Staff Report & Recommendation

Design Review Board

SUBJECT: DRB24-1060
424 W DI LIDO DRIVE

The applicant has submitted plans entitled "W DI LIDO RESIDENCE" as designed by AND Studio, Architecture + Design, dated January 5, 2025. The applicant is proposing to construct a new, two-story residence with an understory area that will replace an existing residence.

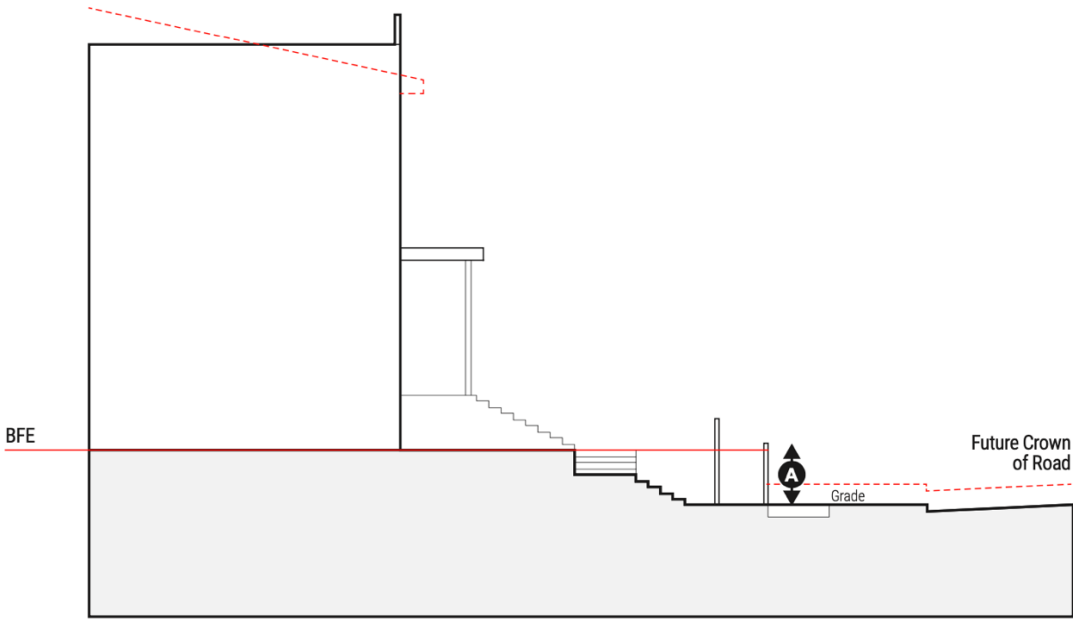
The parcel is located at the southwest corner of the intersection of West Di Lido Drive and the Venetian Causeway. The Venetian Causeway is at an elevation that is as high as 7.8' NGVD as it approaches the bridge that connects to San Marino Island. This is significantly higher than the existing and future grade of West Di Lido Drive. The current grade of Di Lido Drive is 4.3', while the future crown of road is 5.9'.

The large changes in topography adjacent to the property create a hardship for the applicant. Having a roadway higher than the future crown of road elevation, as required by the RS development regulations, creates issues with flooding and water runoff. By raising the portions of the lot, these issues can be avoided, thereby improving the resiliency of the home. The higher elevation of the Causeway also creates practical difficulties, as it would not be ideal from an aesthetic standpoint to have a roadway located at an elevation that is higher than side and rear yards. By raising portions of the yard, the applicant can reduce the potential for future flooding and runoff from the causeway.

The lot would be at a lower elevation on the southern portion of the lot, adjacent to an existing home. This minimizes negative impacts that would be created from the higher ground elevations towards the center and north of the lot. Due to the aforementioned hardship and practical difficulty, staff is supportive of the granting of the variance.
